Nine Mile Point Nuclear Station

SUBJECT: Nine Mile Point Unit 1
Docket No. 50-220
License No. DPR-63

Response to NRC Staff Preliminary Questions Regarding Structural Flaw
Evaluation Methodology Provided via Email dated April 8, 2004 (TAC
MC0930)

Subject: Discussion of Effect of Cladding-Induced Stresses on Evaluation of Nine Mile Unit 1
Closure Head Flaw Evaluation

Figure 1. Typical Stress Distribution in a Clad Plate [from Reference 4]

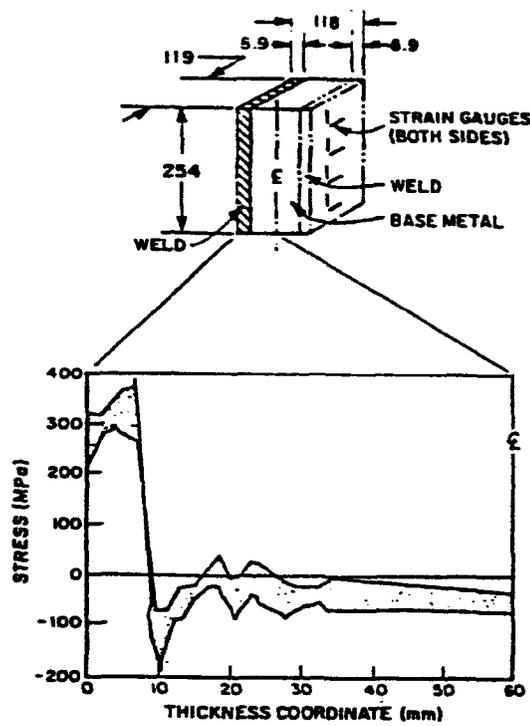
There is a large body of data on the residual stresses in welded clad plate as a result of the application of stainless steel cladding. References 4 and 5 are typical. Figure 1 (from Reference 4) shows the envelope of the residual stresses due to cladding in plate material with a thickness comparable to the NMP top head. This figure demonstrates the discussion in both References 4 and 5 and shows that the room temperature stresses in the cladding are tensile, while the stresses in the base metal are very near zero or compressive. For the NMP flaw that extended from about 10.6 mm to 18.2 mm from the clad ID surface, this figure would indicate that the cladding induced stresses would be compressive at the point nearest the clad-to-base metal interface, and either near zero or compressive at the point nearest the center of the plate. Other figures in References 4 and 5 show that stresses in the entire region are compressive.

One other point is that the membrane stress correction factors for subsurface flaws at Point 1, which is the location that is nearest the surface of the plate, are relatively greater than those deeper into the vessel wall, as demonstrated in the graphs of Figures A-3300-2 and A-3300-4 of Section XI, Appendix A [Reference 3]. Since the stresses are compressive in the region of Point 1 of the NMP flaw, the above-referenced figures clearly demonstrate that the stress intensity factors would be more negative in the regions very near the clad-to-base metal interface. Thus, the effect of the cladding-induced stress is to produce a net small reduction in stress intensity factor for the NMP subsurface flaw.

Thus, it is concluded that the impact due to neglecting cladding stresses on the acceptability of the detected reactor pressure vessel closure head flaw according to the Section XI requirements is either beneficial or not significant.
